APPLICATION NO.	FILING DATE	FIRST NAMED INVENTOR	ATTORNEY DOCKET NO.	CONFIRMATION NO.
10/080,849	02/22/2002	Aaron J. Hanna	K35A1056	9641

Office Action Summary

DETAILED ACTION

FIGURE 5

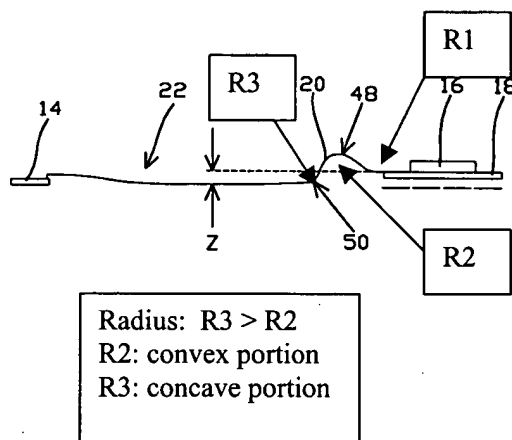
- Regarding claims 5, 10, 14, 18, 22, 26, 31, 36, 41, 46, 50 and 54, Jagt shows the radius geometry includes a first radius of curvature, a second radius of curvature and a third radius of curvature, the first radius being closer to the mount plate than the second radius, the second

radius being closer to the mount plate than the third radius, and wherein the third radius is greater than the second radius [see Examiner's embedded Fig. 5].

In response to applicant's argument that the references fail to show certain features of applicant's invention, the Examiner maintains that Jagt et al. discloses a load beam [12] having a first end and a second end, the first end defining an integral hinge portion, the hinge portion defining a radius geometry that includes at least two radii of curvatures configured to lower load beam toward the disk such that the hinge portion defines at least one concave portion and at least one convex portion [col. 8, lines 8-38; Examiner's embedded Fig. 5];
